2 Type of change

- Change of the plastic screw nut for mounting

Product Change Notification					PCN Plastic Screw Nut Harmonisation		
owner	creation date	release date	released by	change order no	rev	page	D10-032-450
rescalfa	29.11.2018	06.12.2018	pingelme	2016800	A	1 of 8

Old screw nut dimension and appearance	New screw nut dimension and appearance
<p>Mounting diameter M16:</p>	<p>Mounting diameter M16:</p>

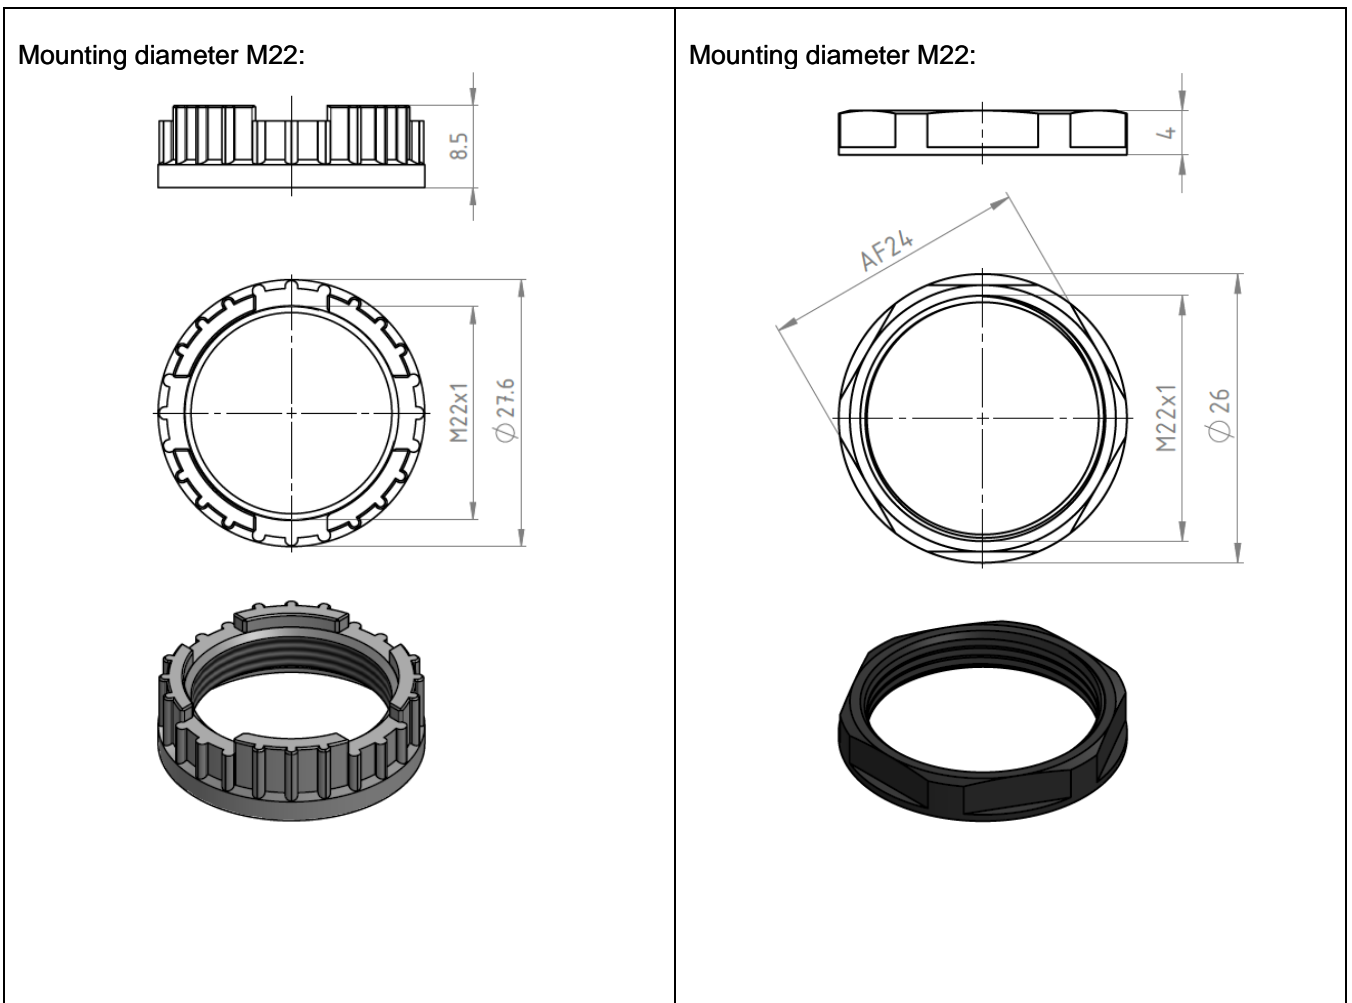
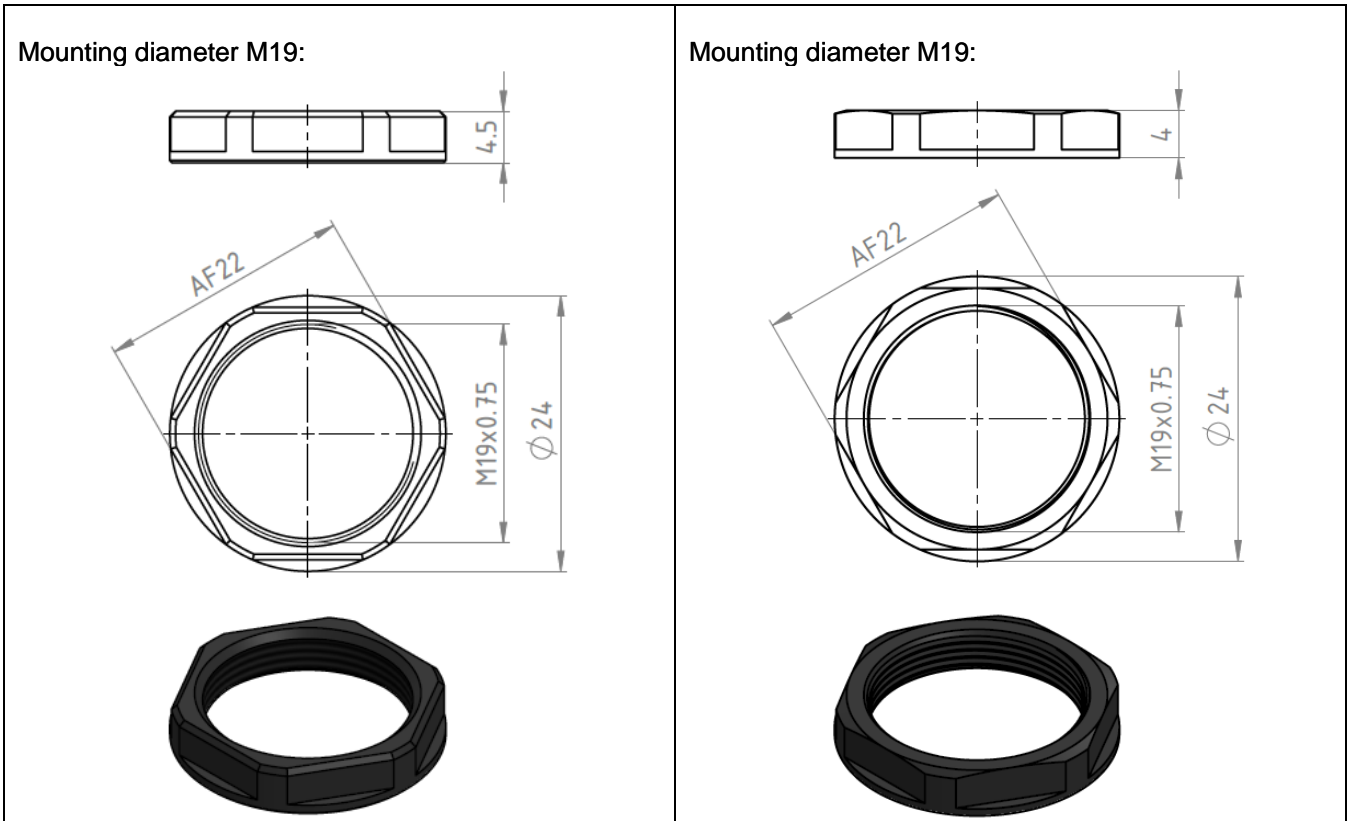
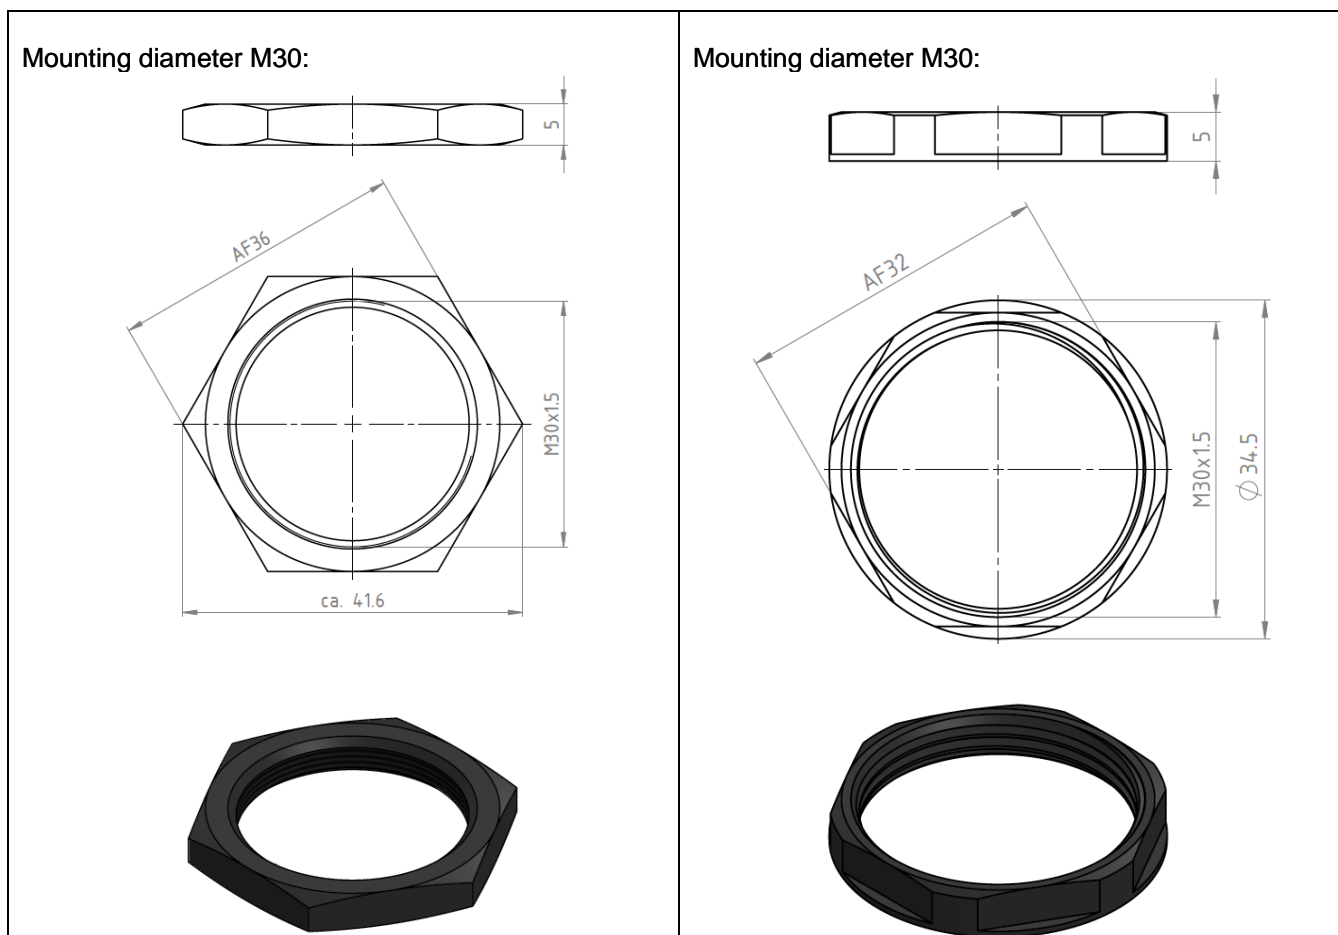
- Harmonisation of all plastic screw nuts within the entire product range

Form	Yes	Change of screw nut design
Fit	Yes	Change of screw nut dimension
Function	No	No change in function
Manufacturing	No	No change for manufacturing site
Label	No	No change on label
Packaging	No	No change in packaging
